Model  
2-6195

COMMENTS CONCERNING REQUEST FOR LEAK TEST EXEMPTION

MEMORANDUM

Details of F & M High Temperature Electron Capture Detector

1-6716 • A

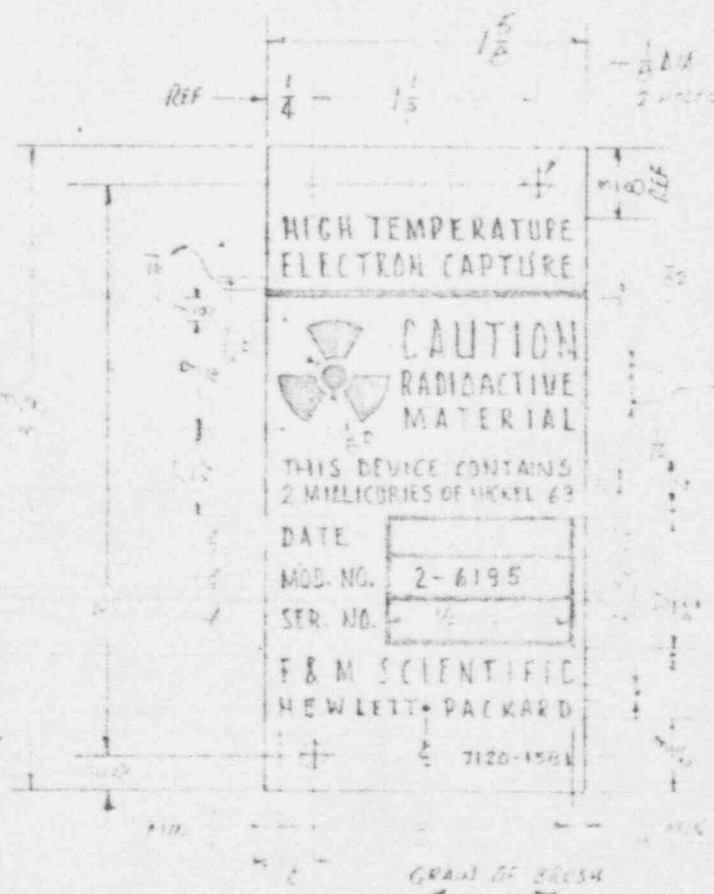
My quick evaluation of the data that F & M indicates they provided to the Commission reveals a matter which I would like you to be certain the licensing people catch. The blue-prints on the proposed name plates show the radiation symbol upside down. Since the American Standards Association and the International Standards Organization have approved a uniform symbol, I would like to urge the licensing people ~~that the~~ to require that the universal symbol be utilized in this case.

to require
